Bid Clarification #3

Park Place East – Office: Shell Package

RFI LOG

Misc Steel Questions

2nd Floor West Stair

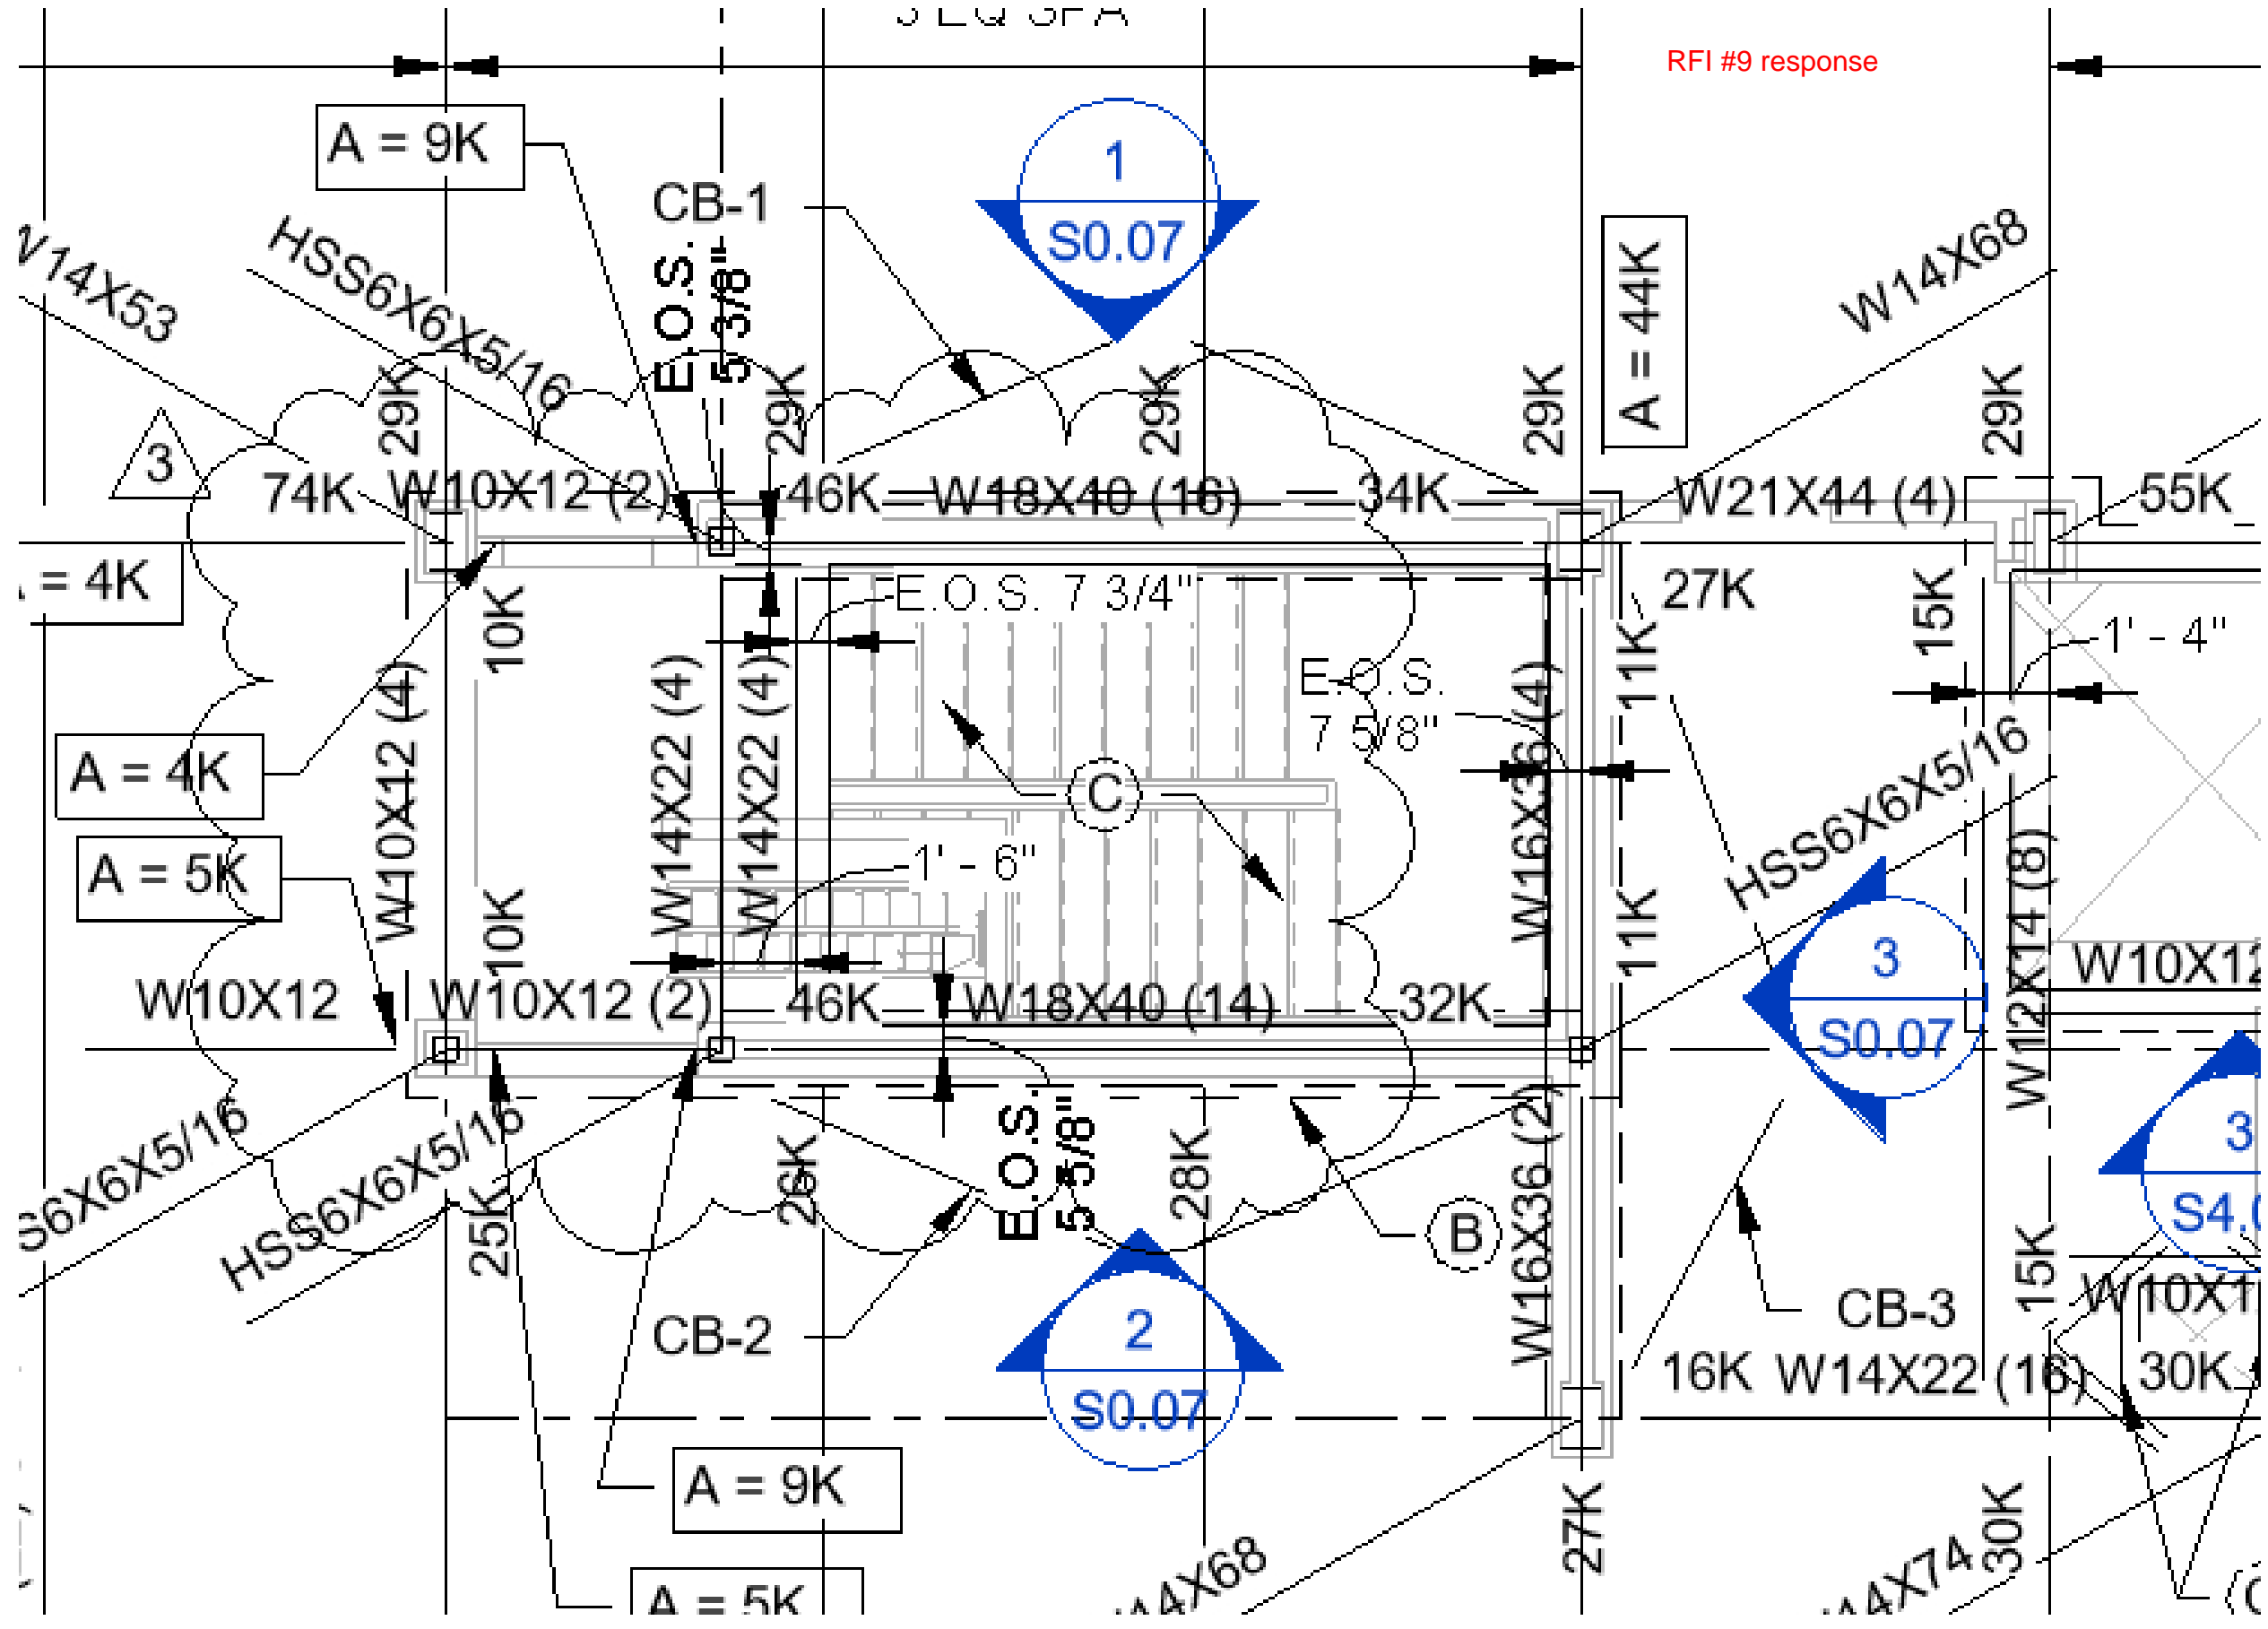
Question from Matt Brooks (MW Builders, Inc. (KS)) at 03:49 PM on 06/06/2018
1. Addendum 1 drawings show a conflict between the structural and architectural at the west stair. Sheet A0.11 & A0.12 show a bump out at grid line 4.8 but the structural do not. Which is correct?

- All Replies:
1. Provide landing dimensions per architectural at 2nd floor, modify per attached at 3rd floor. Provide 6.5" slab on deck from grid 5 to east of grid 4.8 at 2nd and 3rd floor with overhangs per arch and per attached. Additionally provide a W14x22 beam with (4) headed studs on grid 4.8 between grid B and B.4 at each level. (See attached)

ARCH: Update to detail 1/A6.01, updated extent of slab under access ladder, adjusted wall/soffit behind ladder.

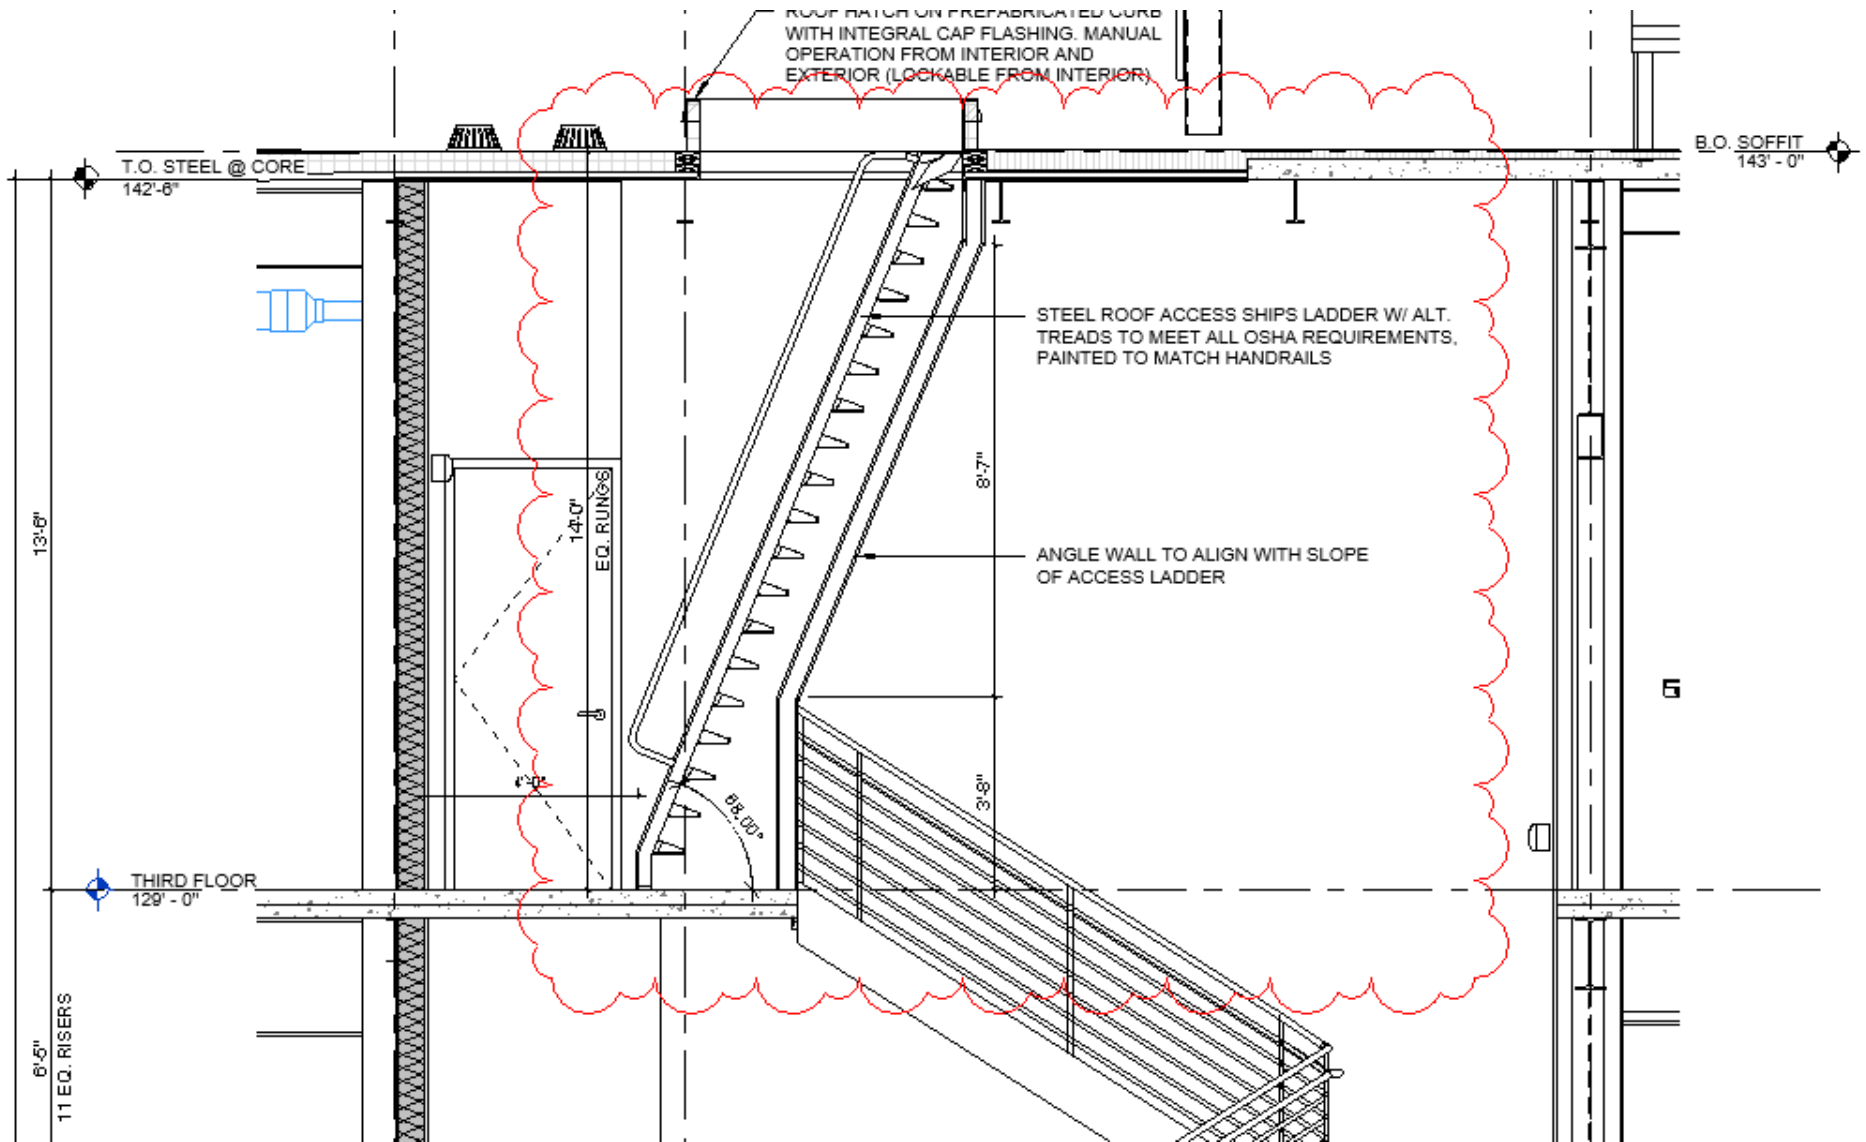
3. Regarding the steel plate welded to the stair stringer per detail 4, 5, and 6 on A6.02, would it be acceptable to use a lighter gauge steel? If it is left as plate, there will need to be a joint line in several locations due to stock length restrictions.

RFI #12 - attachment

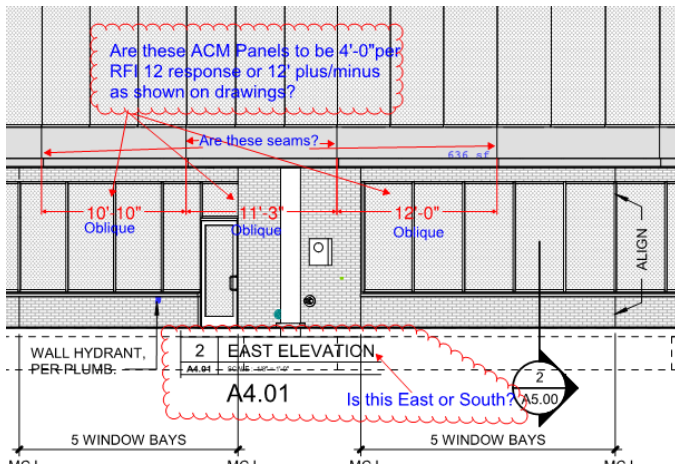
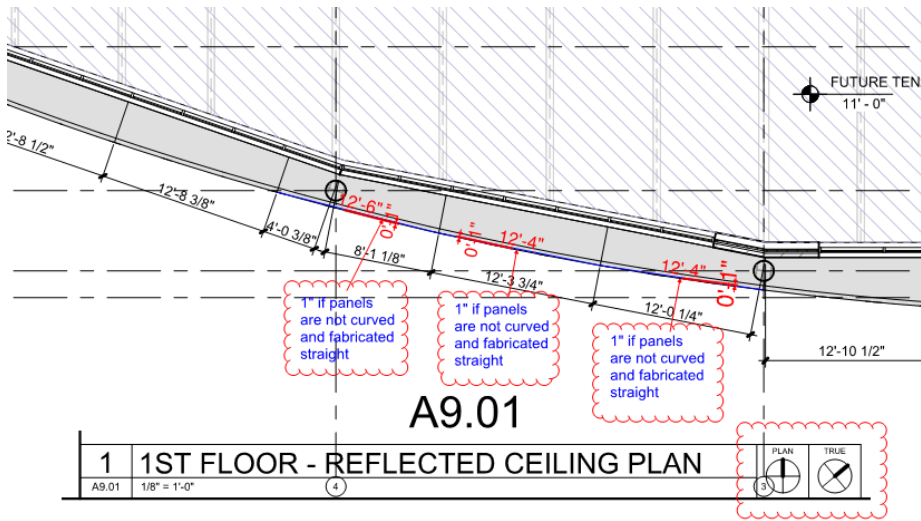
12	Curved Wall	Closed		None	Callow, Alex (Fin... Foster, Ellen (Fi...	06/08/2018	Natalya Steinke	06/11/2018	06/08/18					
	<p>Natalya Steinke Sent Fri Jun 8, 2018 at 08:32 am CDT Q: Please confirm that the panels on the curved wall are not to be truly curved, but to be straight pieces segmented and pieced together. Budget assumed segmented with breaks at the window mullions. See attached description from the glass subcontractor RFI 12 attachment.pdf</p> <p>A: Alex Callow (Finkle + Williams Architecture) Responded Fri Jun 8, 2018 at 08:57 pm UTC Additional question responses: 1. We have revised the labels on A4.01 & A4.02 (attached) to match the plan north directions. The curved wall is now 'Plan South'. 2. The ACM panels should break at every third mullion, as shown on the elevations. The panels will be around 12' in length, and should curve to match the slab edge. The glass system is faceted. 18-0608 PPE Core-Shell_RFI 12_ARCH Elevations.pdf</p> <p>Natalya Steinke (MW Builders, Inc. (KS)) Responded Fri Jun 8, 2018 at 04:17 pm UTC Additional questions from subcontractor on the same subject: A: 1. Q1- The RCP plan A9.01 shows the "Plan North". Directional arrow as pointing upward on the page. This appears to me that it makes the curved wall the "South Wall". However, the Elevation of the Curved Wall calls it out as the "East Wall". Is the curved wall Plan Direction considered the "South Wall" or the "East Wall"? 2. Q2- In the RFI 12 response it is clear that this wall is laid out in straight segments. However the typical length of 4'-0" segments appears to be for the Glass Curtain Wall Window Mullions and "NOT for the ACM MP-1 or MP-2 Panels? Please note that the ACM Panels are around a consistent 12'-0" plus/Minus dimension. When they span 12'-0" +/- the bisector of the chord can extend three times + further than than that of a 4'-0" faceted dimension. I re-attached the snap-it snap shot and increased the size of the clouded notes so they are readable. I have also added a snap shot of the Upper and lower elevation ACM Panels. Are the ACM Panels 12'-0" plus/minus length as drawn or are they to decrease to 4'-0" to match the CW Mullions?</p> <p>See attached snips. RFI 12 attachment (2).pdf</p> <p>A: Ellen Foster (Finkle + Williams Architecture) Responded Fri Jun 8, 2018 at 02:36 pm UTC The design intent for the 'curved' wall has always been segmented pieces. I cannot read the clouded notes on the attachment, but the intent is to have straight 4'-0" segments that make up the faceted curve.</p>
